Re: Item No. 12.1

AGRICOLA STREET DEVELOPMENT

- HALIFAX -

- DESIGN IMPROVEMENTS -

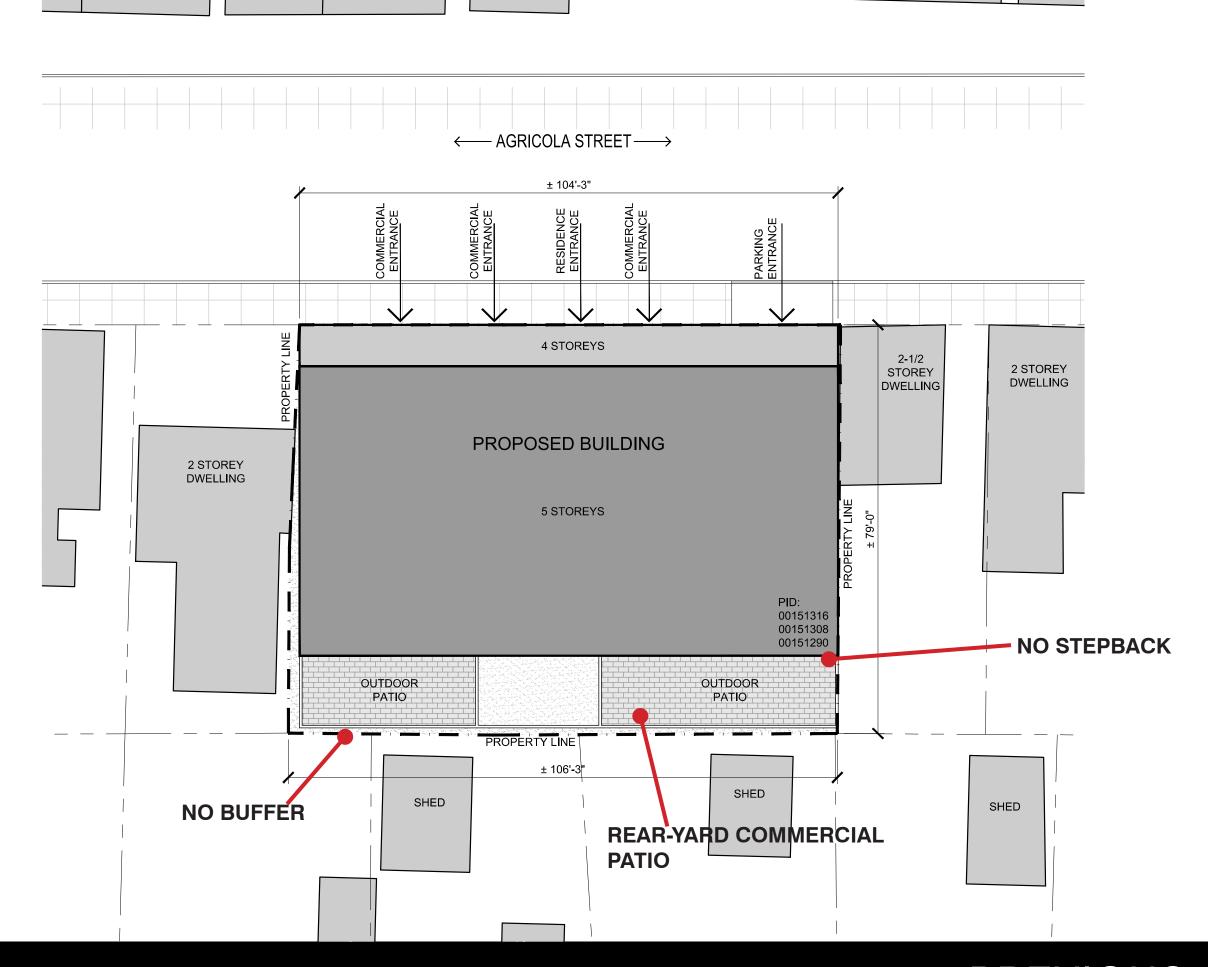
4. A concealed vehicular parking entrance could impact pedestrians along Agricola Street;

✓ below-grade parking and parking entry were removed

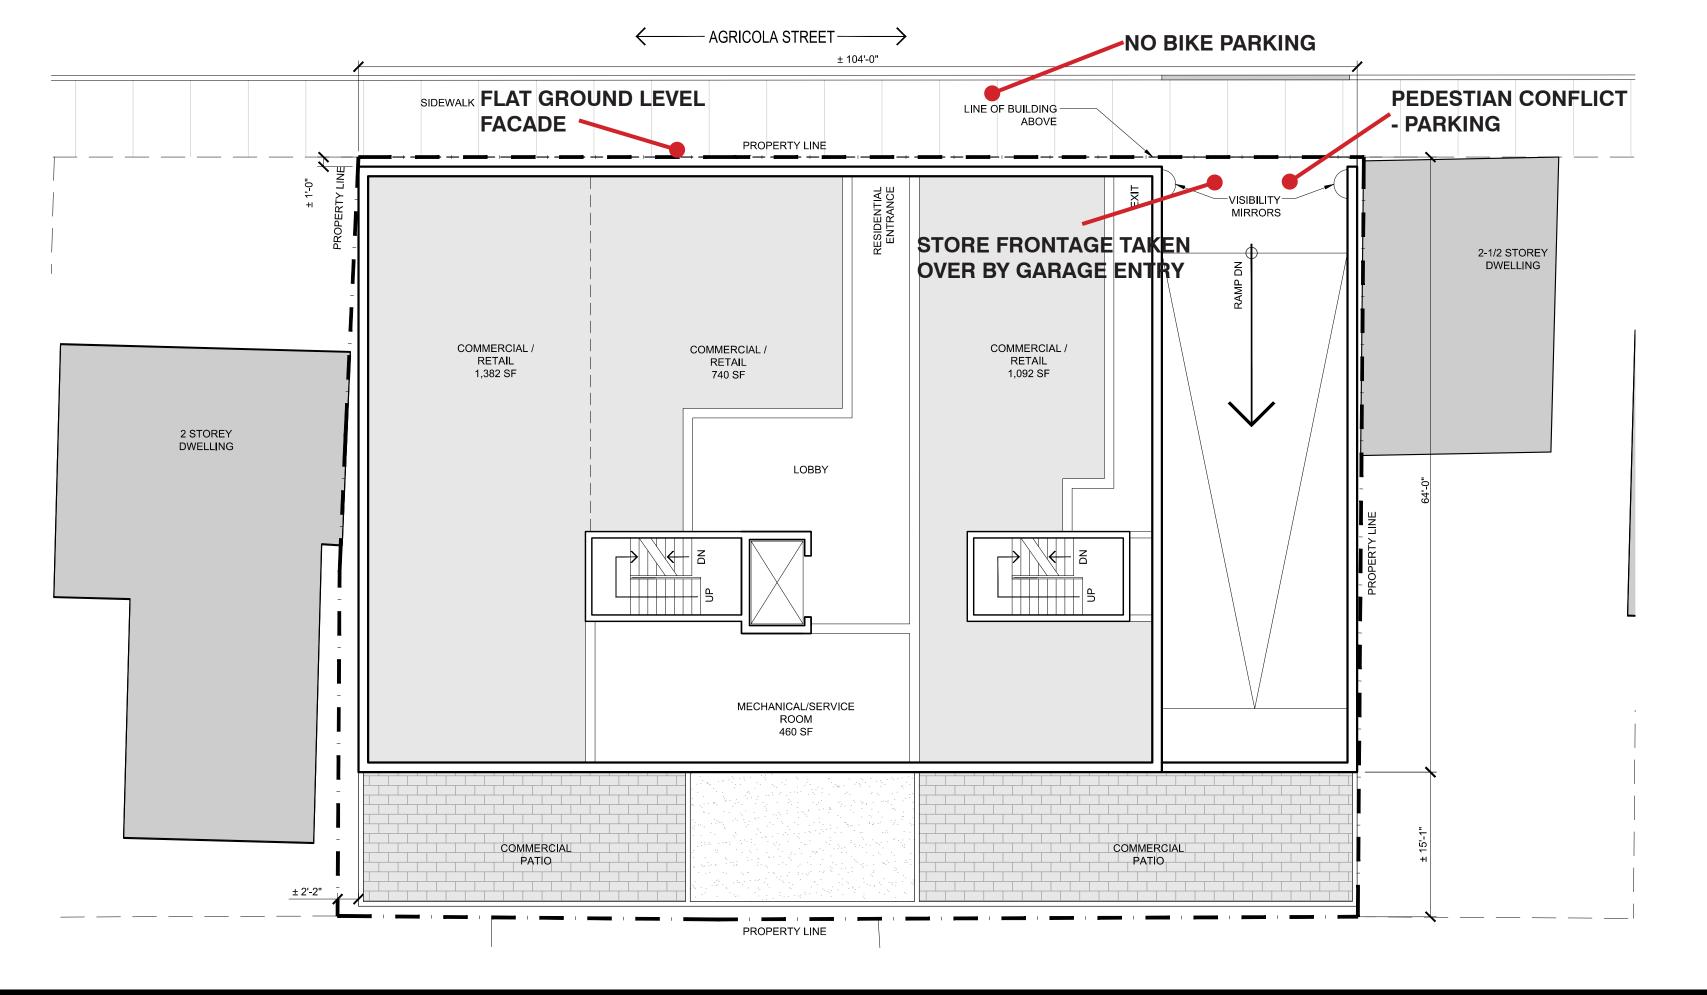
5. A three storey streetwall would be more appropriate than a four storey streetwall:

✓ Streetwall height along Agricola Street was reduced from four storeys to three storeys;

PROPOSED PERSPECTIVE VIEW - AGRICOLA SOUTHBOUND

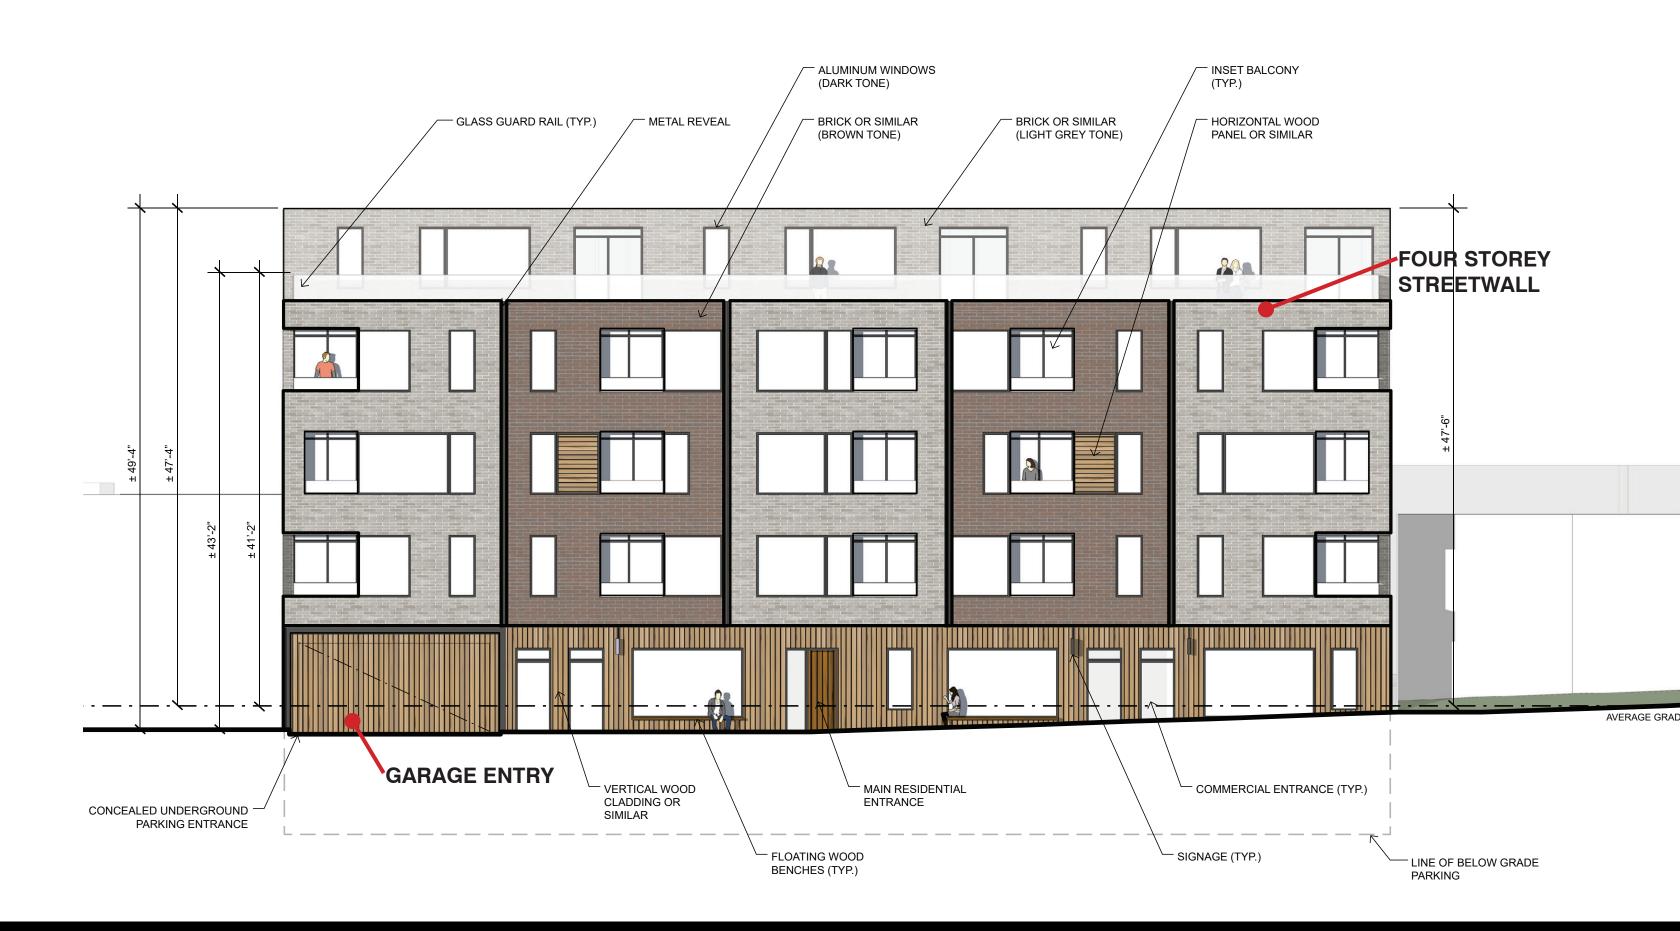
6. An overall height of four storeys is recommended unless further measures to improve transition are incorporated:

✓ We believe that this was achieved through the substantial modifications to our initial proposal including building articulation, reduction in streetwall height, increased setbacks and stepbacks, removal of underground parking and rear commercial patios, and increasing the amount of vegetative buffer.
